WASH-1400-APP-11
(NUREG-75/014-APP-11)

Reactor Safety Study

**ANALYSIS of COMMENTS
on the
DRAFT WASH - 1400 REPORT**

**APPENDIX XI
to
REACTOR SAFETY STUDY**

Figure XI 5-1 Corrected Fault Tree for Event U.
(T/M = Test and Maintenance)

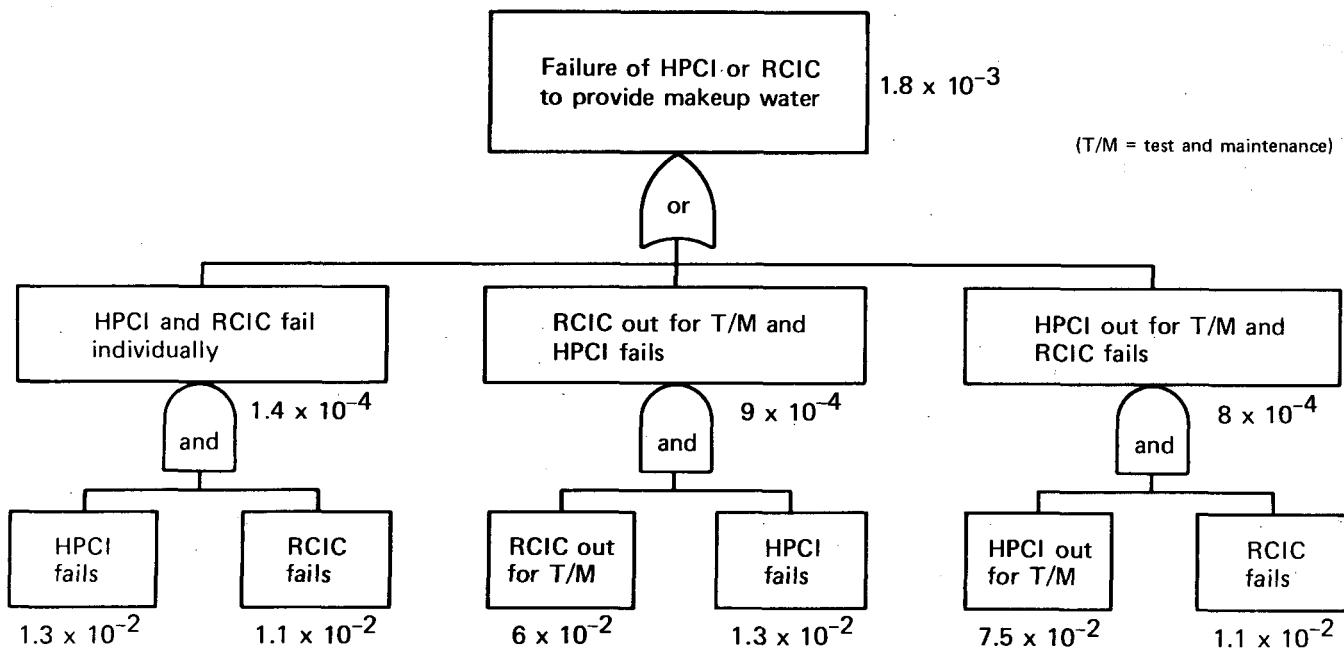
The coupling treatment discussed in Appendix II, volumes 2 and 3, must also be recognized as being only part of the total dependency analysis that was performed on the RPS. In the actual evaluation, Monte Carlo simulation was performed using the tight coupling and independent values as bounds to obtain

the estimated probability distribution and median value for the rod failure dependencies and the RPS total unavailability (as described in section 3.6.2 of Appendix II, volume 1). Furthermore, the failure rate coupling procedure was also used to incorporate dependencies into the rod drop failure rates (as described in section 4 of Appendix IV). The final RPS unavailability was used in event tree quantification and incorporated the Monte Carlo simulation of the tight coupling and independent bounds and the failure rate coupling dependencies as stated in section 4 of Appendix IV.
